U N I V E R S I T Y O F SOUTH CAROLINA

AMENDMENT NO. 1

SUBJECT: USC-IFB-2290-LW
Bat Removal, Exclusion and Clean-up at USC Hamilton College

DATE: August 8, 2012

FIRST FLOOR PLAN - 016
DATE: 07AUG12

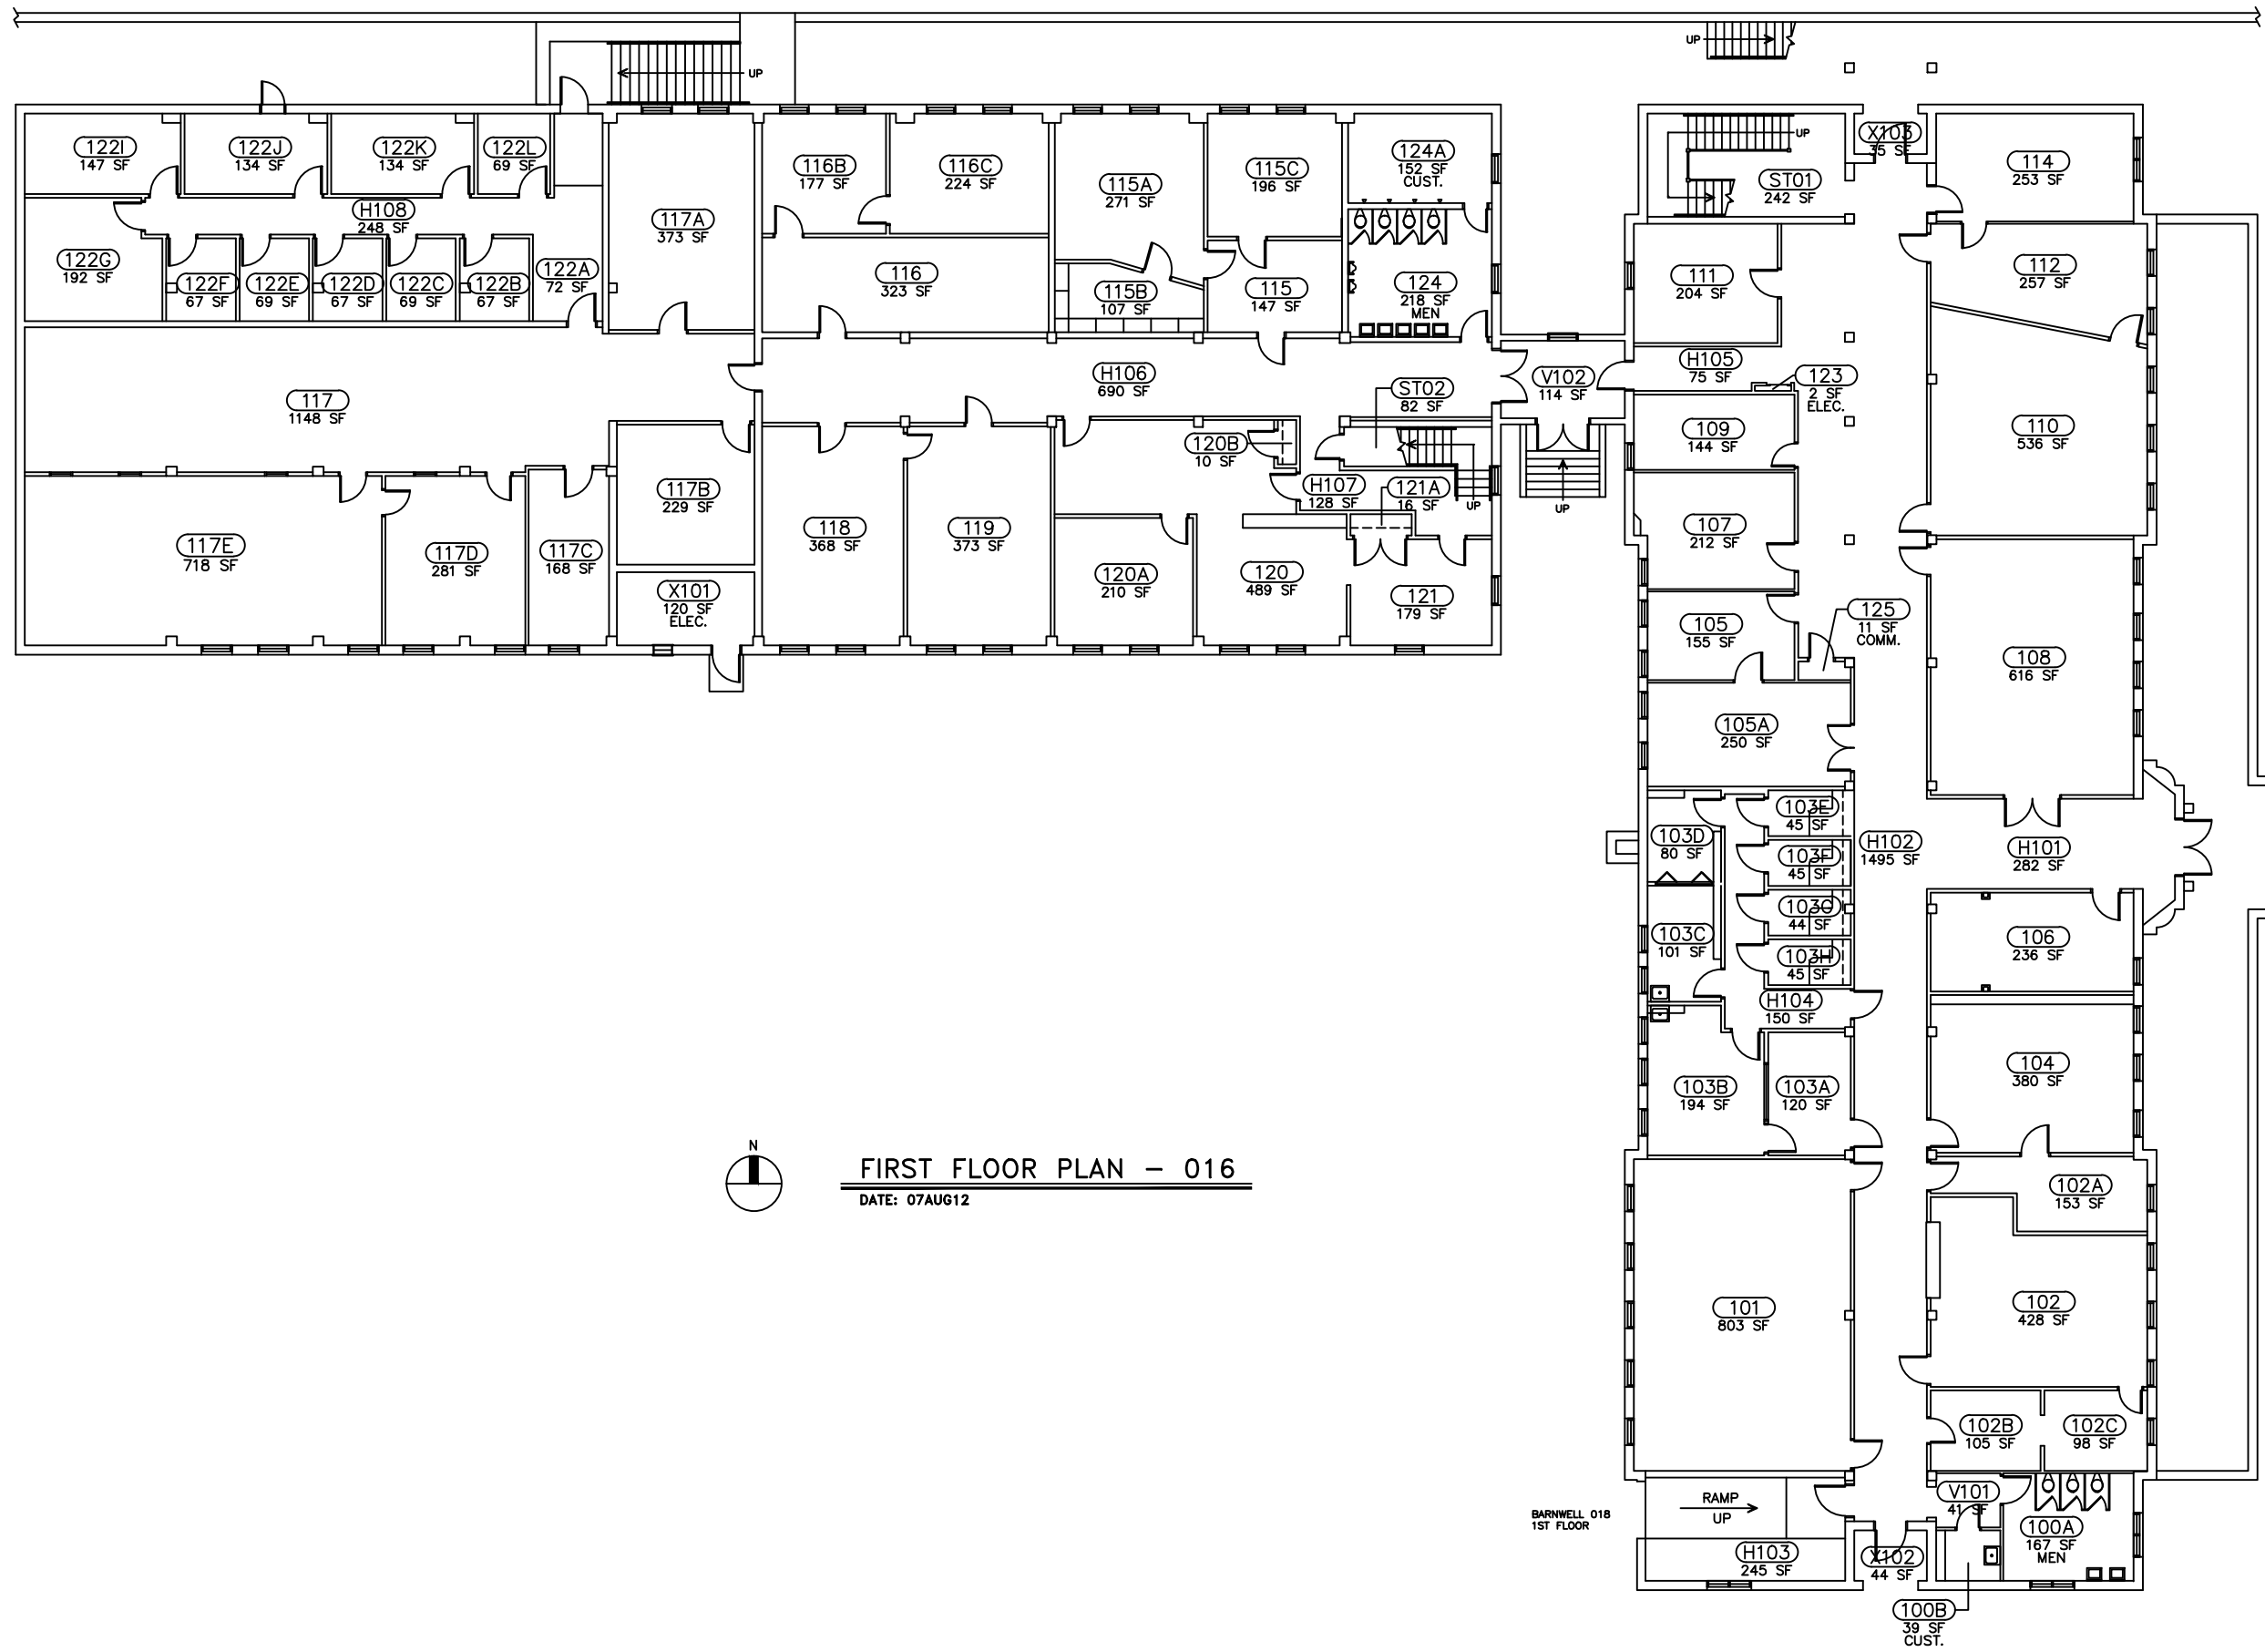
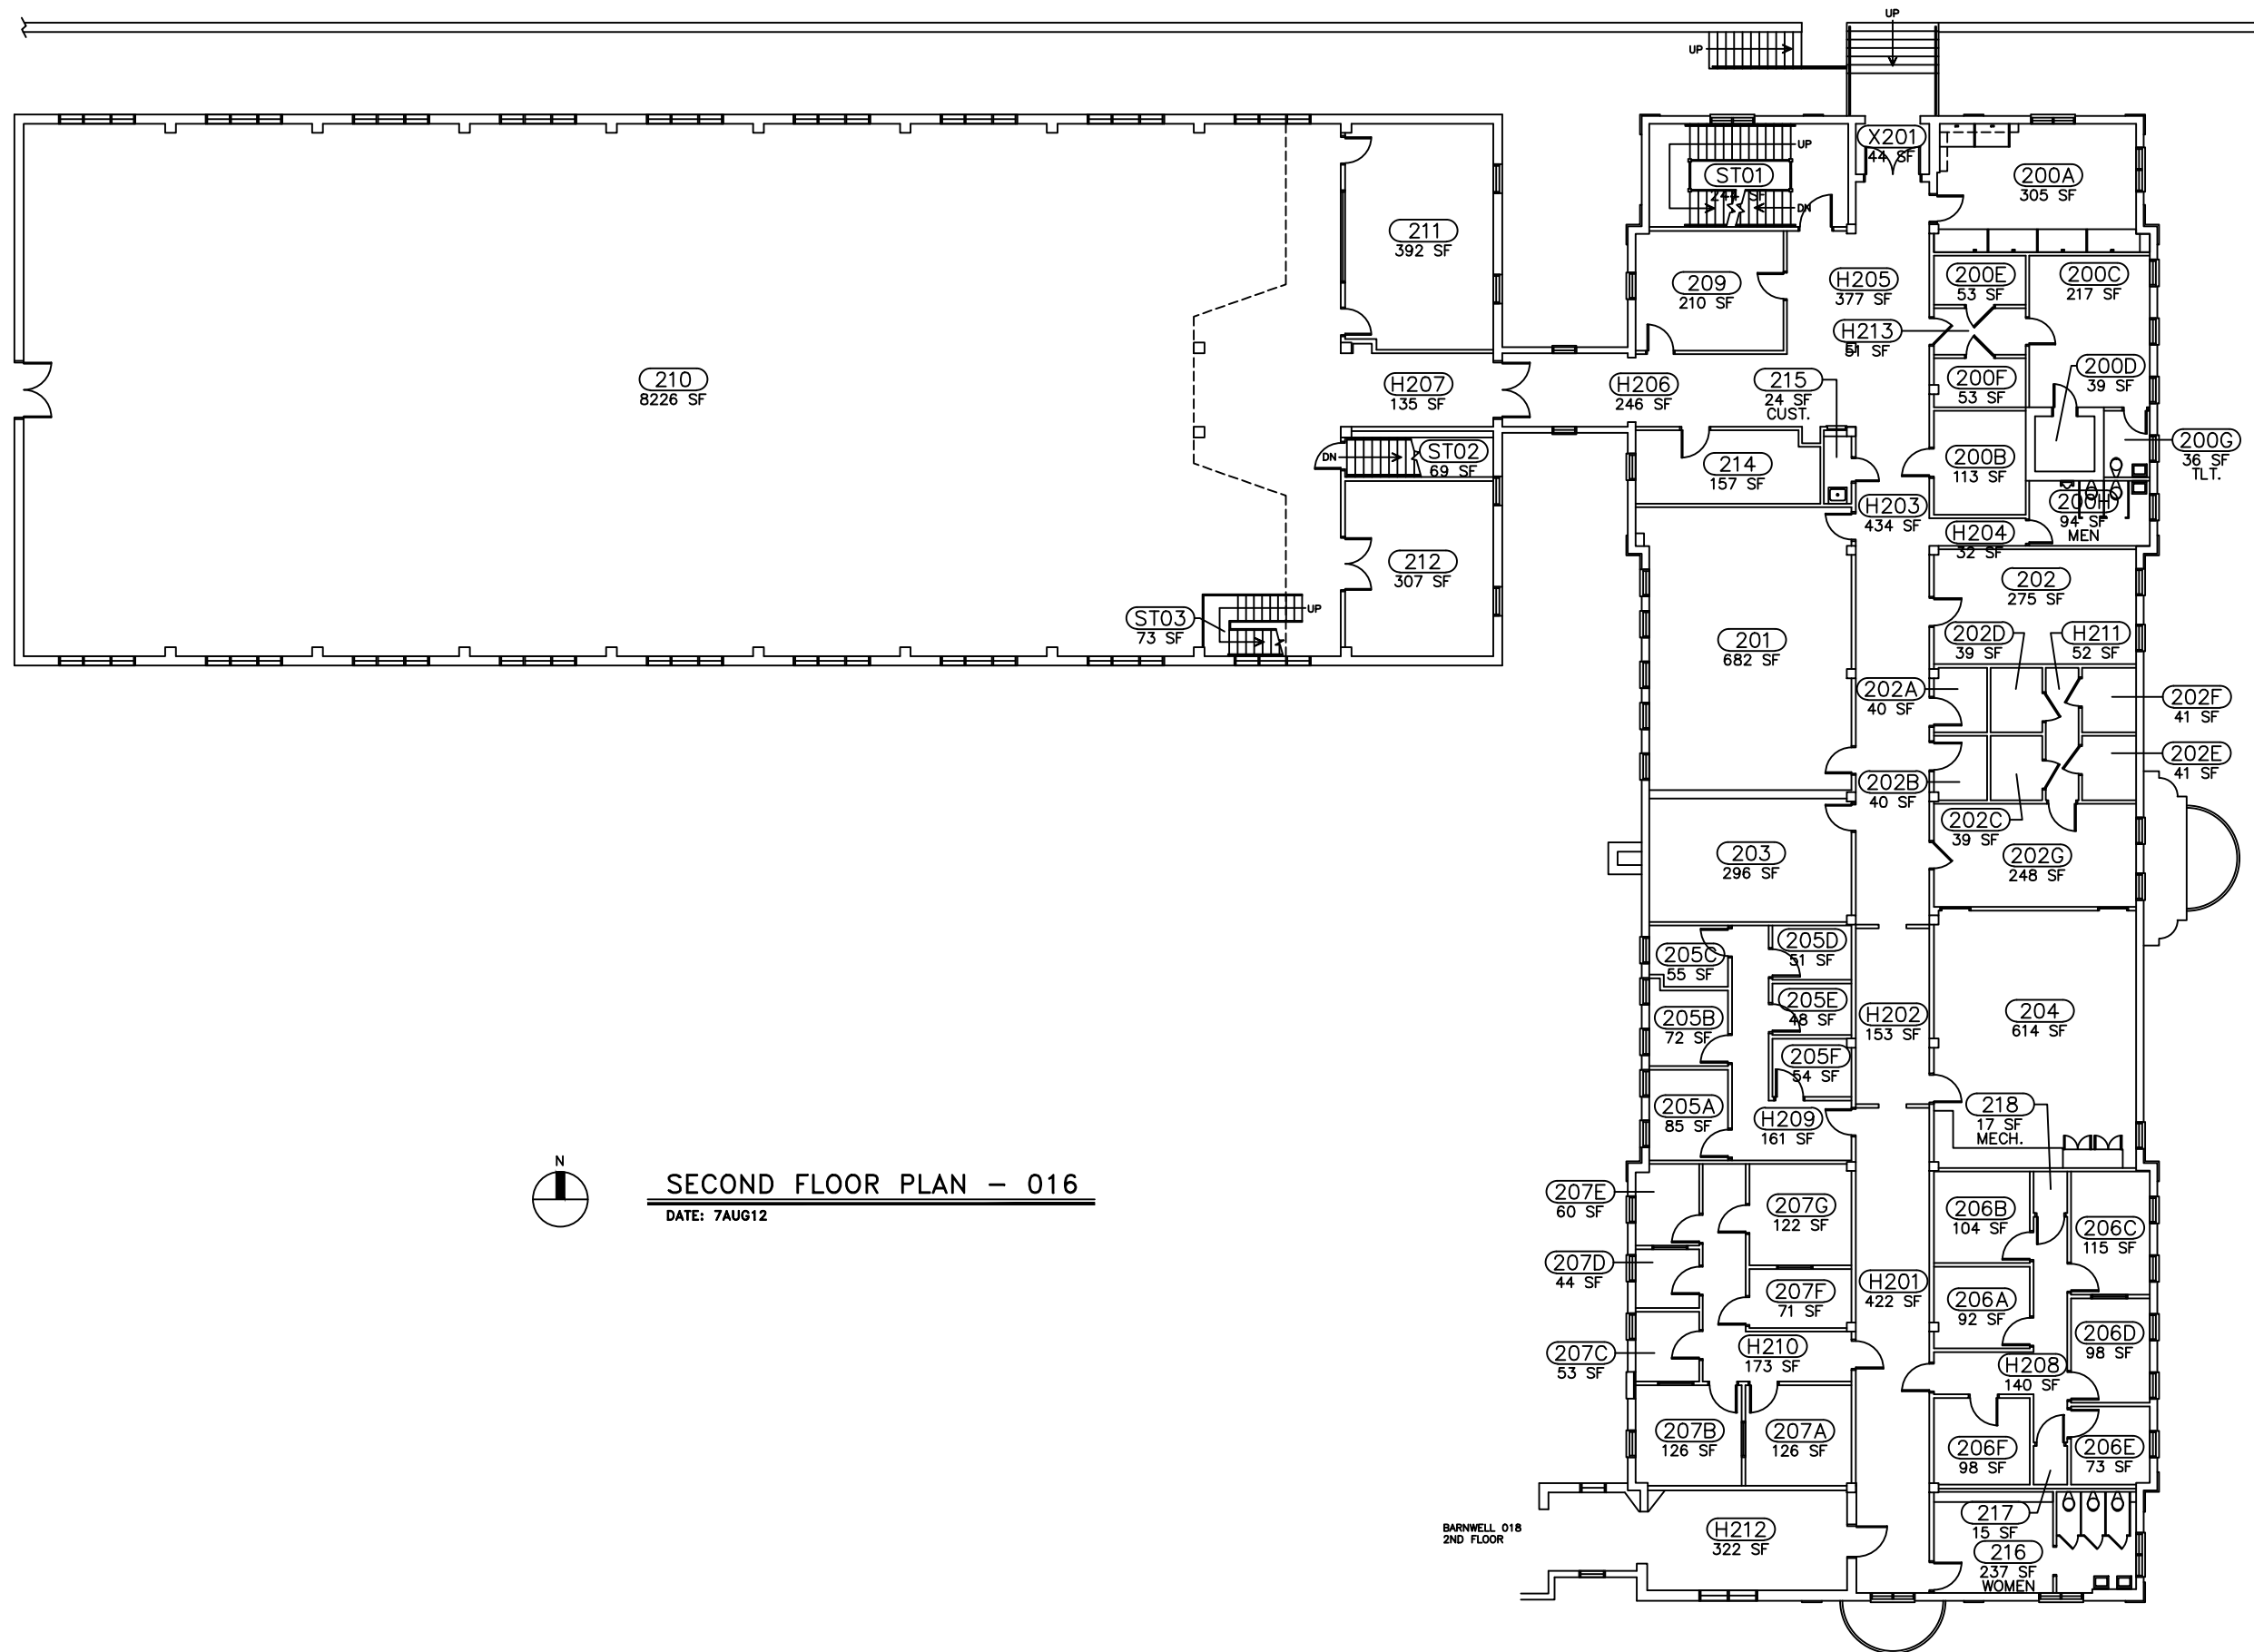
Will you supply a diagram or plan for the building?

PDF copies of the current square footage floor plans for Hamilton College (Building #016) as on file are attached for your use.
